LEE'S SUMMIT
MISSOURI
Development Services Department

Development Services Staff Report

File Number	PL2020-219
File Name	REZONING from AG and R-1 to R-1 and PRELIMINARY DEVELOPMENT PLAN – The Ridge at Winterset Summit (previously titled Winterset Cedar Creek)
Applicant	Engineering Solutions, LLC
Property Address	2550 SW 3 rd St
Planning Commission Date	October 22, 2020
Heard by	Planning Commission and City Council
Analyst	Victoria Nelson
Checked By	Hector Soto, Jr., AICP, Planning Manager and Kent Monter, PE, Development Engineering Manager

Figure 1- Existing topography

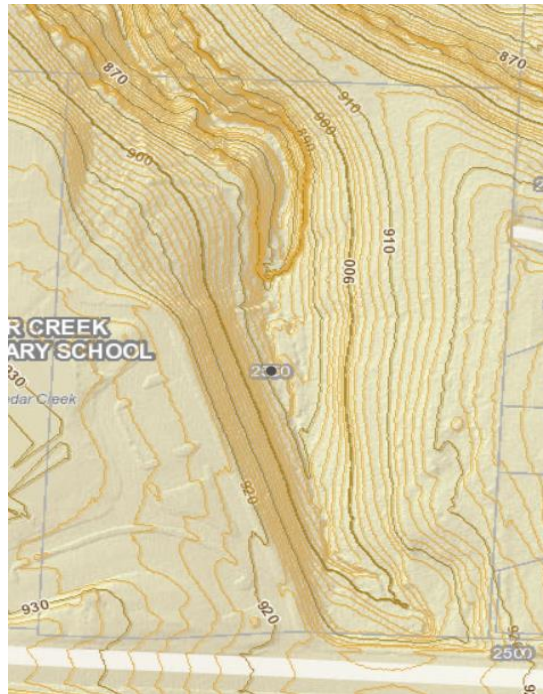
- Recommended – Except where topography or other conditions justify their use, cul-de-sacs are generally discouraged in subdivision design. The subject property has significant topographical features that inhibit the ability to provide an interconnected grid or modified grid street system (see image below). The proposed subdivision well exceeds the maximum number of cul-de-sac lots allowed in a subdivision, all attributable to the topographical challenges presented by the property. Staff supports the requested modification.

1. A modification shall be granted to the 10% maximum allowance of cul-de-sac lots in a subdivision, to allow a combined 26% cul-de-sac lots between The Ridge at Winterset Summit and Winterset Park subdivisions.
2. A modification shall be granted to the minimum 30' front yard setback requirement, to allow the requested 25' for Lots 2 and 3, and 20' for Lot 4 for The Ridge at Winterset Summit subdivision.
